CITY PLAN COMMISSION STAFF REPORT

Project Name
Skyview Crossing at Tiffany Springs

Request
CD-CPC-2024-00118
Development Plan

Plan Conditions

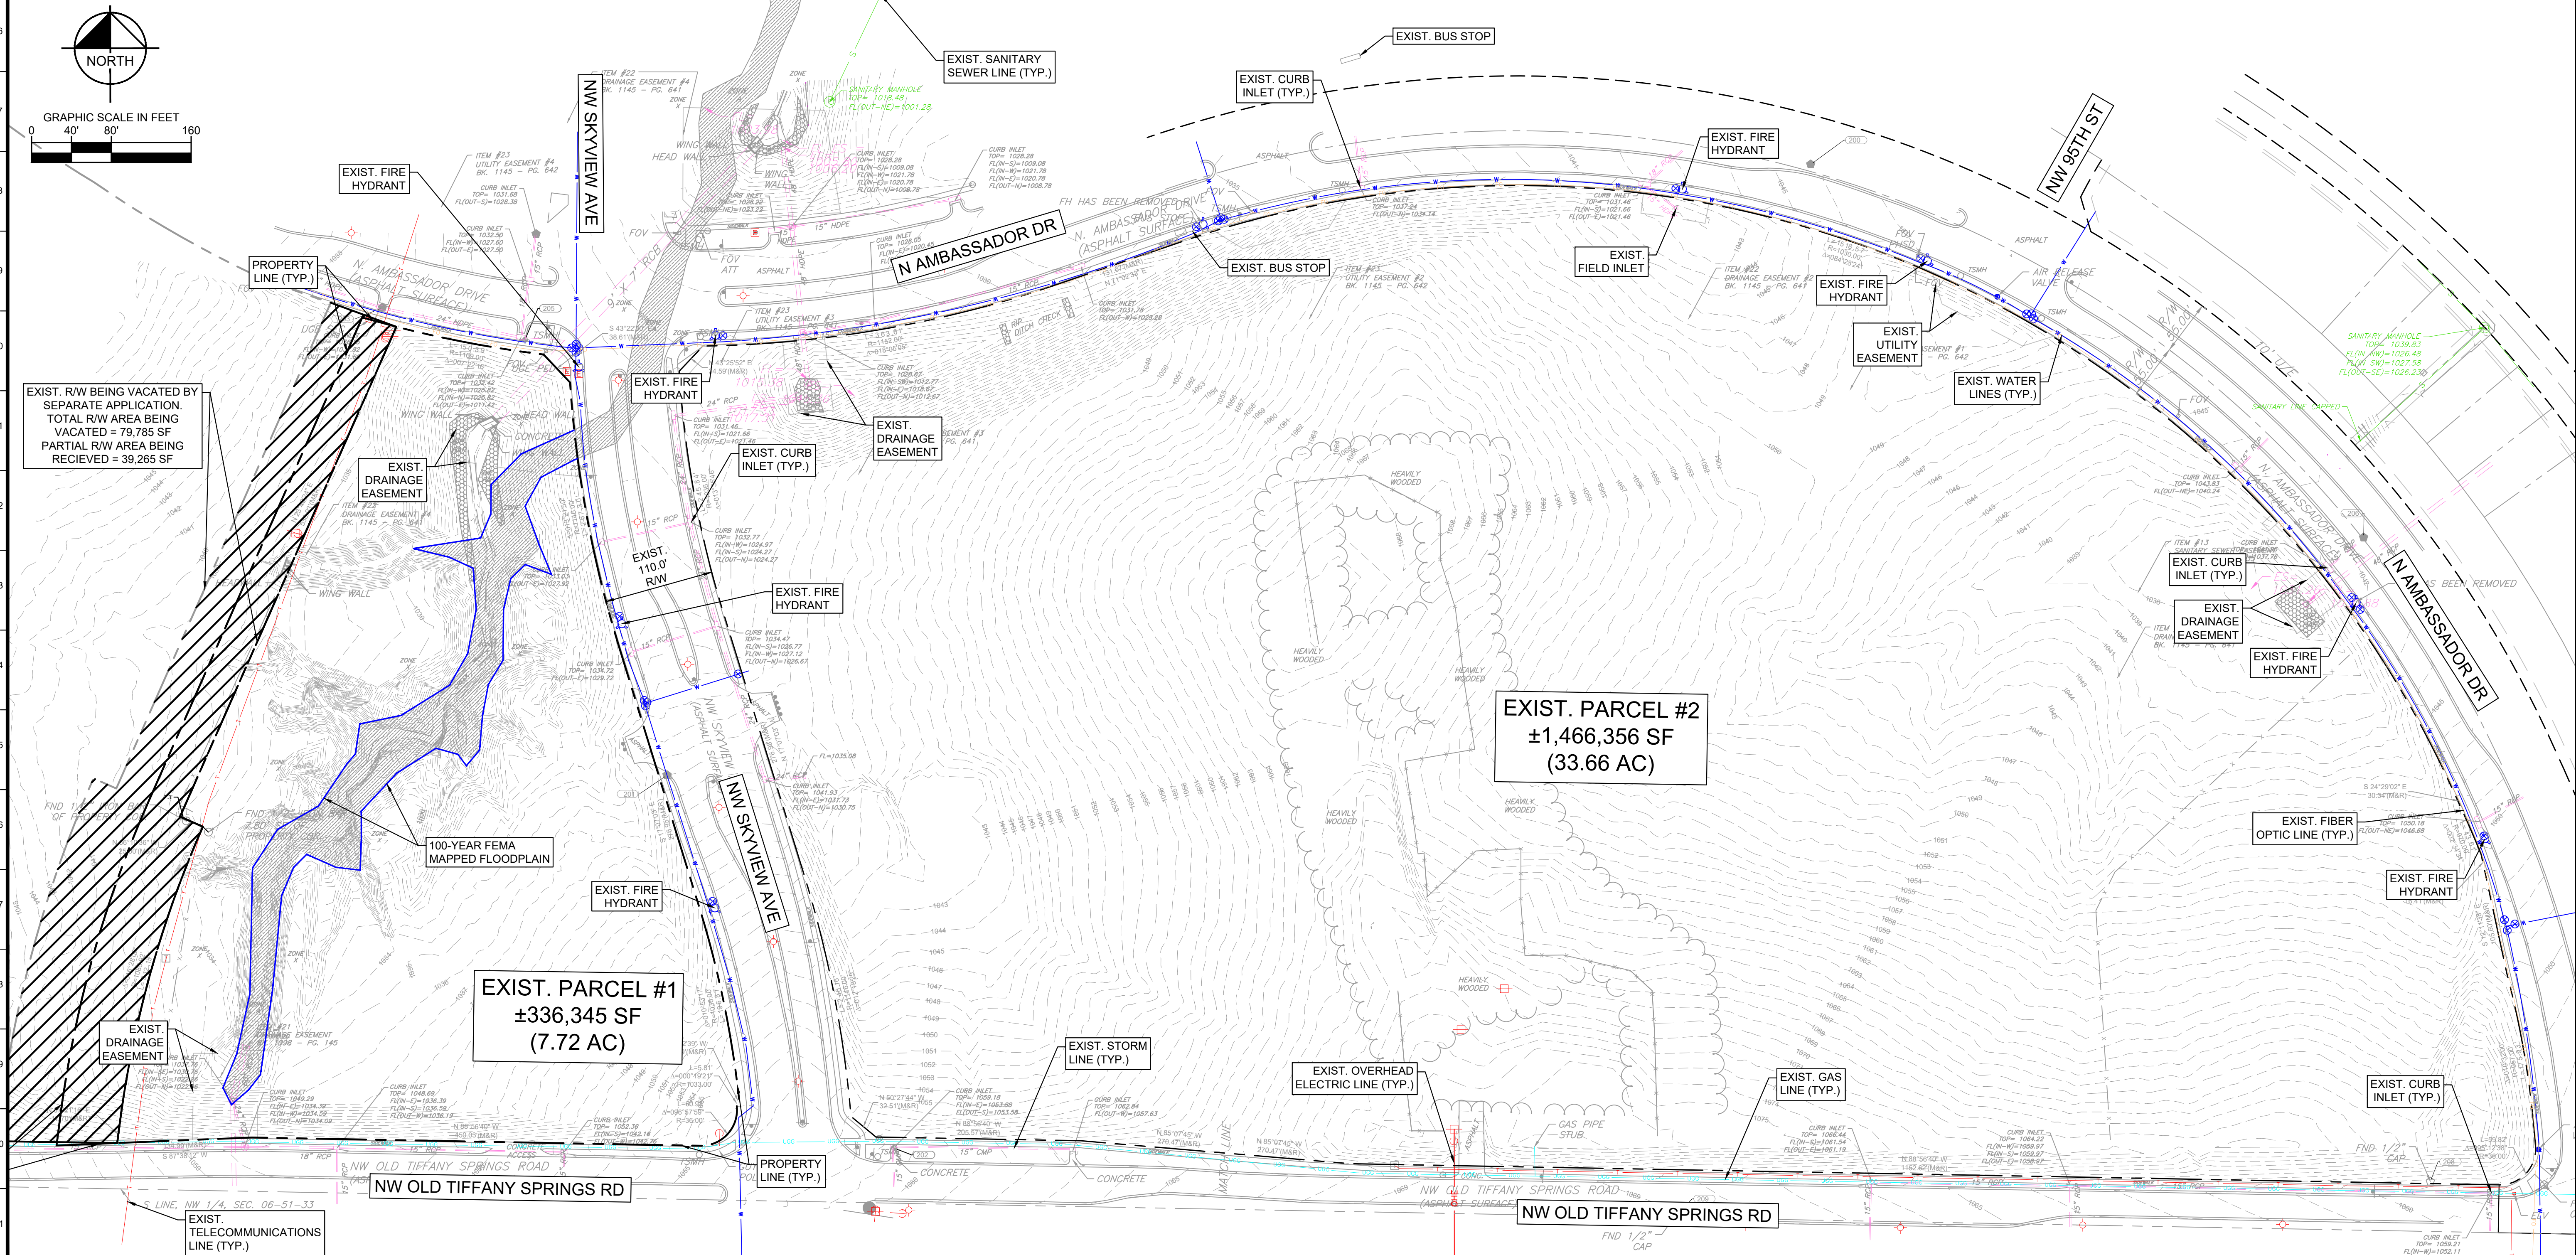
10. That prior to being heard by the City Council the applicant revise the plans to satisfy Water Services corrections to revise the deviation note on the cover to request not installing the extension of approximately 750' of 12" DIP public water main with fire hydrants along NW Old Tiffany Springs Road between NW Skyview and the western property line. (The text in the note that this main extension would not serve this development is not accurate as the requested main extension provides a portion of the looped connection west toward the transmission main which when completed will improve the distribution system reliability and redundancy.

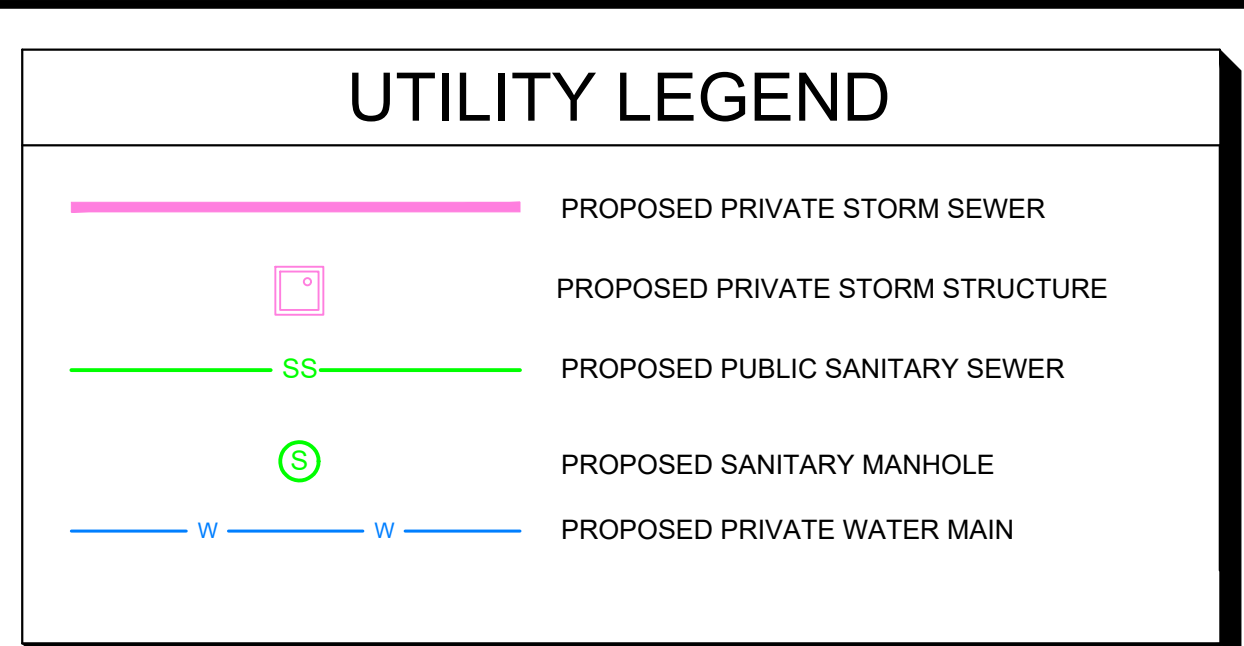
29. Submit water main extension plans for the extension of approximately 750' of 12" DIP water main and fire hydrants along NW Old Tiffany Springs Road from NW Skyview Ave. to the western property limits. The water main extension shall follow all KC Water Rules and Regulations for Water Main Extensions and shall be under contract (permitted) prior to building permit issuance.
